Access Compliance Report

Public Rights-of-Way

(Curb Ramps)

Intersection ID: 10033675	Main Street: ORCHARD_LAKE_DR	Cross Street: N/A	Location: W
ADA ID: B534D4A48335	Ramp Type: Perp	Initial Pass/Fail: Pass	Overall Compliance: No
		Severity Score: 0

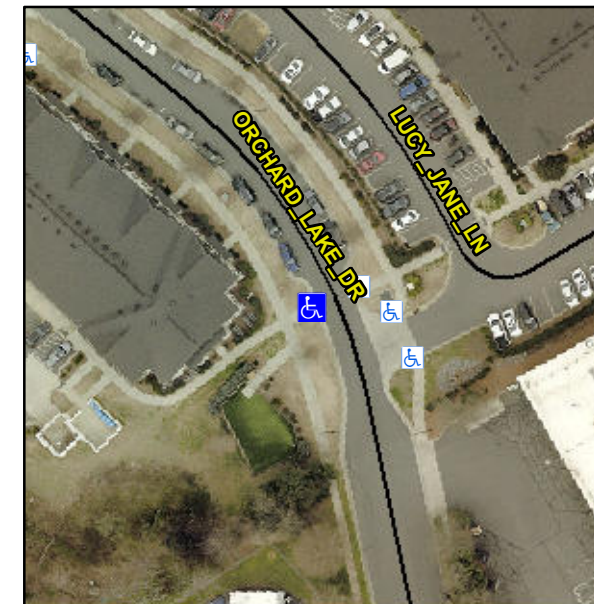
**R304.2.2-Perp, R304.3.2-Para,
R304.5.3**

**Remove & Replace Landing.
Remove & Replace Gutter.**
